North Haven P&ZC Hearing April 19, 2021

Opposition to Slate Upper School

Slate Upper School Opposition P&ZC Hearing Outline

SCALE 1" = 50'±	COMM. NO. 00005.00	DATE 12/15/2020
EXISTING CONDITIONS PERVIOUS VS IMPERVIOUS PROPOSED SCHOOL 5100 RIDGE ROAD, NORTH HAVEN, CONNECTICUT PREPARED FOR: ACAMPORA - NORTH HAVEN CSB		
1

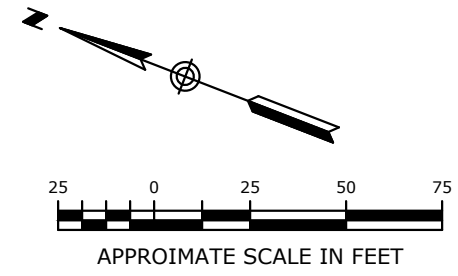
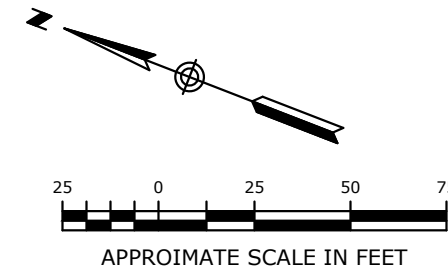
1. Earthwork Quantities-To put this project in proper perspective, we have estimated the amount of earthwork required to accommodate the building, site improvements and infrastructure. Based on the grading plans, approximately 6,629 cubic yards of cut and 8,162 cubic yards of fill activity will be required. This will require the import of 1,533 cubic yards of material to establish grades and additional material of unknown quantity will have to be imported for structural fill for building foundation, subgrade fill under parking and other hardscape areas and special material for the sewage disposal and stormwater systems. This will create a significant site soil management/storage problem as well as parking and traffic issues as a number of large trucks will be using Ridge Road which has serious limitations as identified in the various traffic studies.

2. Topography and Grading-According to the submitted topographic survey plan the topography of the site varies 28 feet along the site frontage and 48 feet along the rear. In order to accommodate building, site development and infrastructure, extensive site clearing and grading is proposed over approximately 80 % of the site. The average cut is 4+ ft. and the average fill is 4+ feet with some cuts and fills in the 12-13 foot range. This extent of earthwork will create a landform that is not consistent with the character and rural residential setting of the site and surrounding neighborhood.
